Access Compliance Report

Public Rights-of-Way

Intersection ID: 17822	Main Street: CORDER_DR	Cross Street: PINEY_GROVE_RD	Location: NW
ADA ID: 1DDFA58F9790	Ramp Type: PerpDiag	Initial Pass/Fail: Fail	Overall Compliance: No
		Severity Score: 25

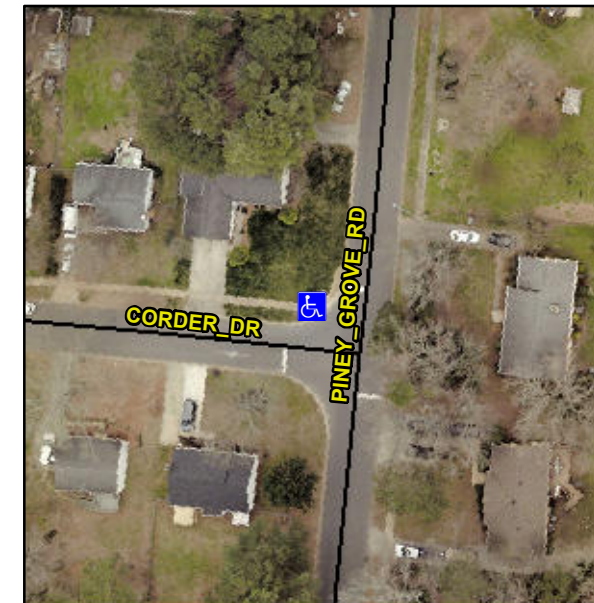
Not Found, R304.2.2

Compliance	Description	Data	Compliance	Description	Data
N/A	Ramp Length (in)	25.0	No	Ramp Slope (%)	14.3
Yes	Ramp Width (in)	48.0	Yes	Ramp XSlope (%)	1.3
N/A	Flare Type LT	N/A	N/A	Flare Type RT	N/A
N/A	Flare Slope LT (%)	N/A	N/A	Flare Slope RT (%)	N/A
N/A	Flare Traversable LT?	N/A	N/A	Flare Traversable RT?	N/A
N/A	Landing Length (in)	N/A	N/A	DWS Provided?	N/A
N/A	Landing Width (in)	N/A	N/A	DWS Contrast?	N/A
N/A	Landing Slope (%)	N/A	N/A	DWS Length (in)	N/A
N/A	Landing X Slope (%)	N/A	N/A	DWS Full Width?	N/A
N/A	Landing Curb? (Y/N)	N/A	N/A	DWS Offset (in)	N/A
N/A	Shared Landing?	N/A			
N/A	Gutter Ponding?	N/A	N/A	Gutter Slope (%)	N/A
N/A	Gutter Lip Ht (in)	N/A	N/A	Gutter X Slope (%)	N/A
N/A	Painted X Walk1?	No	N/A	Painted X Walk2?	No
	X Walk 1 Direction	To SW		X Walk 2 Direction	To SE
N/A	X Walk 1 Width (in)	N/A	N/A	X Walk 2 Width (in)	N/A
	X Walk 1 Slope (%)	1.7		X Walk 2 Slope (%)	4.2
	X Walk 1 X Slope (%)	1.0		X Walk 2 X Slope (%)	0.1

Remove & Replace Curb Ramp With Two New Directional Ramps or Equivalent.
